Vitacress Salads Ltd

Application reference: P.5767/H/95/V001 & P.5768/H/95/V001

Activity 1a and 1b: D block

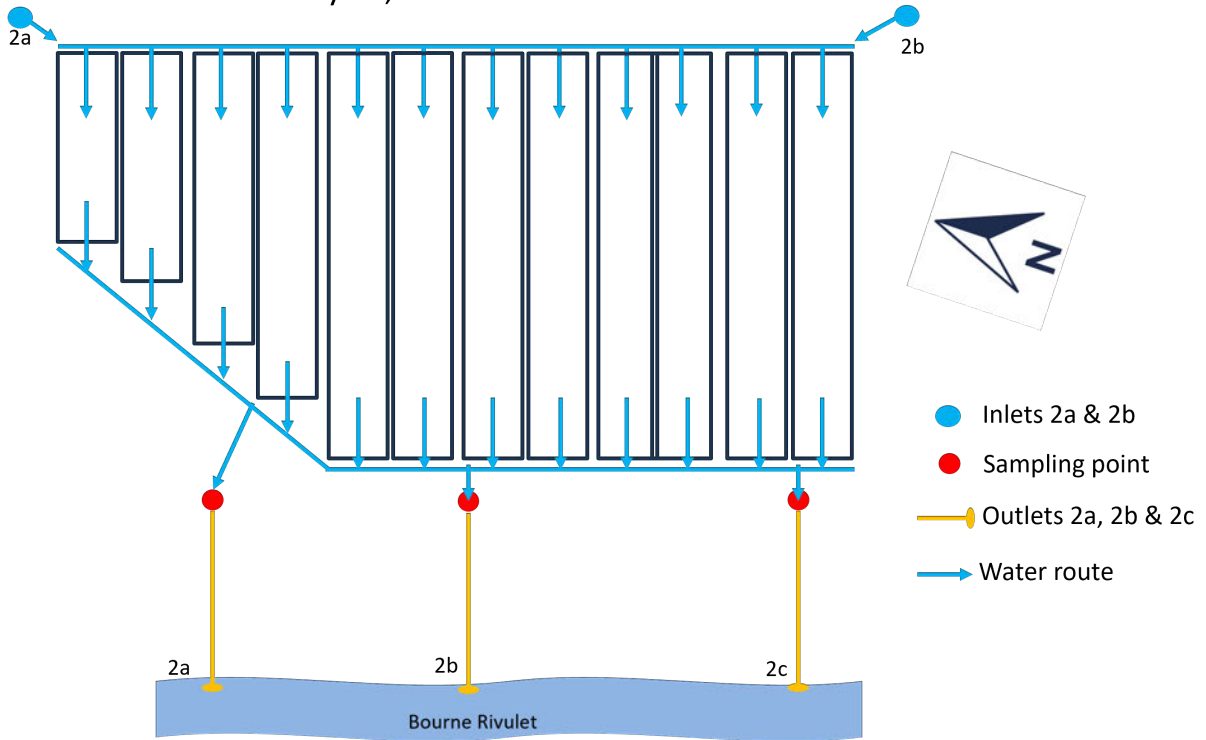
Updated schematics

These are attached at the end of this letter. Activity labels will be updated in the main EMS as soon as possible.

Activity 4: vegetable washing

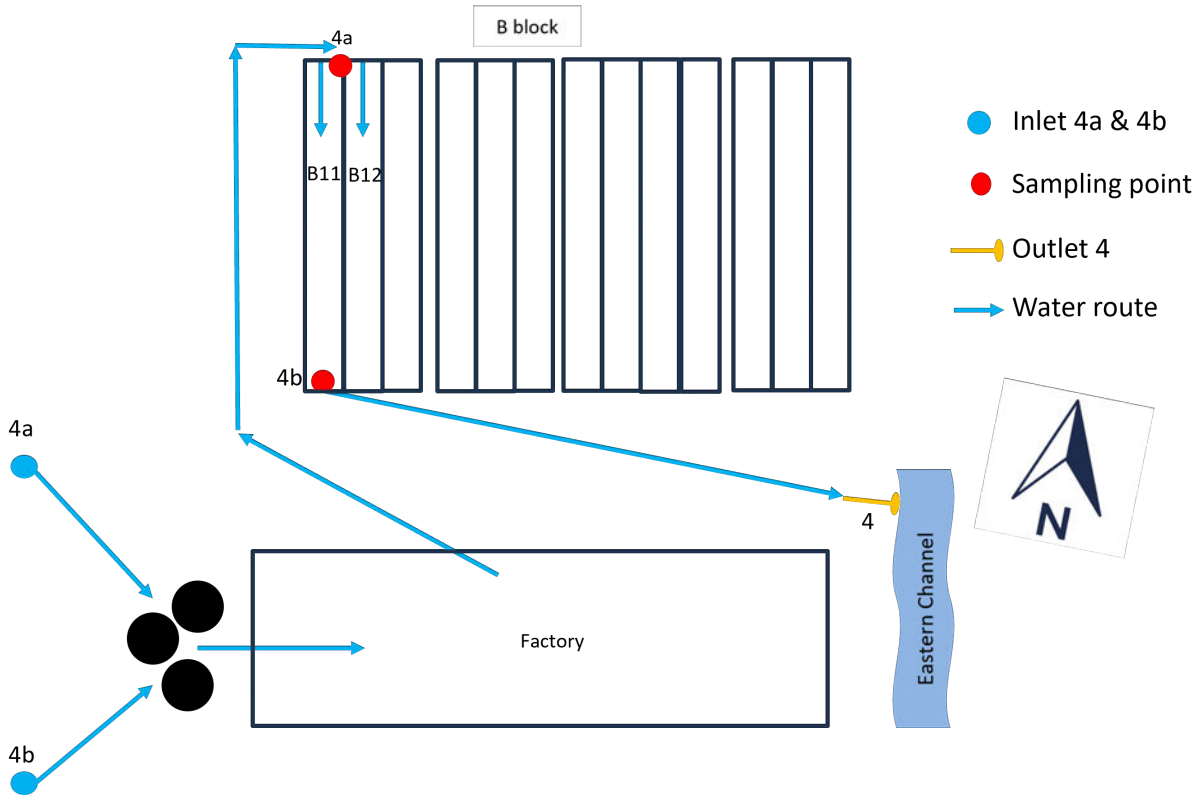
Reasons for not discharging to the sewer

Vegetable washing water is discharged to the eastern channel and not the sewer. This is due to the volume of water discharged from the factory. The Southern Water trade effluent discharge consent allows for a maximum discharge rate of 5.15 l/s, and a maximum daily limit of 445m³. Therefore, vegetable washing effluent cannot be discharged to the sewer.
